ADDENDUM NO. 02

PROJECT:	Ossining Union Free School District Ossining High School Guidance Office Renovations
SED PROJECT NO:	66-14-01-03-0-003-039
DATE:	January 04, 2021
CPL PROJECT NO:	14428.12

1.2 Drawing OHS/E100:

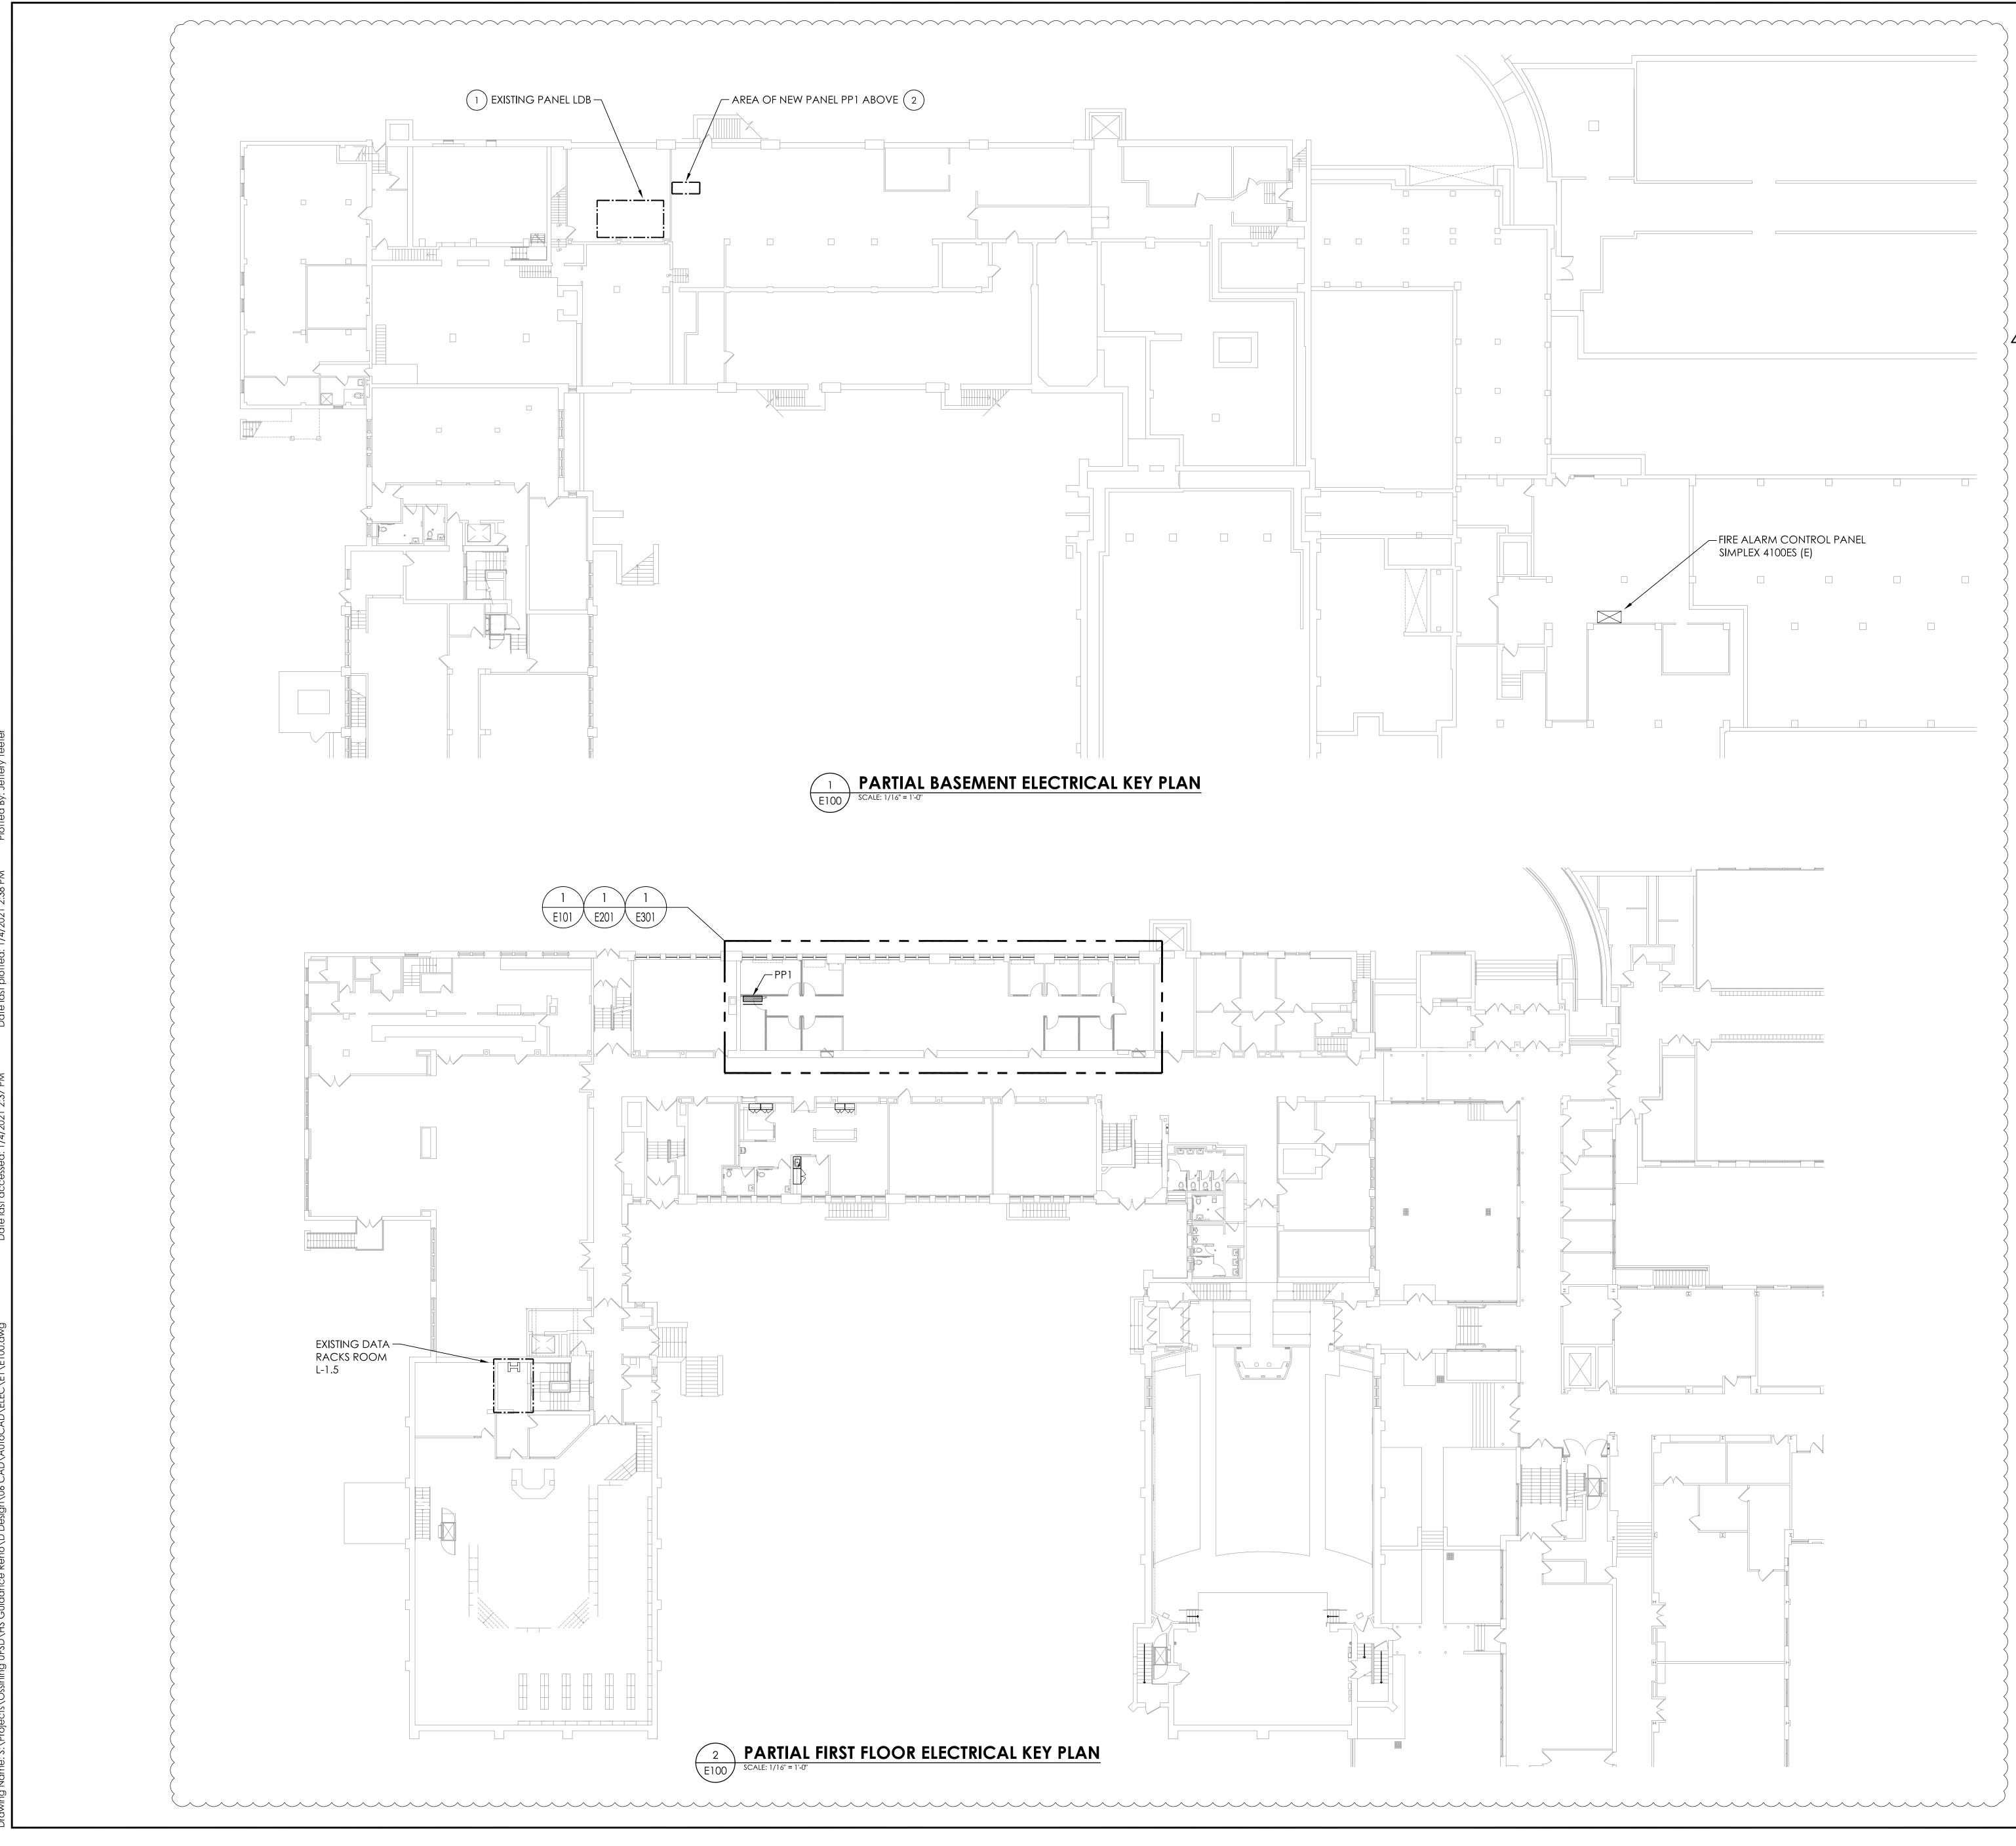
1.1 Question: Drawing OHS-E100, it appears that the maximum length for data cabling will be exceeded based on the current data rack location. Is this acceptable? *Answer: This is not acceptable. Scale noted on plans on Drawing OHS-E100 were mis-labeled. Refer to the replaced drawing attached to this addendum.*

A. Replace Drawing with Drawing OHS/E100, attached to this addendum.
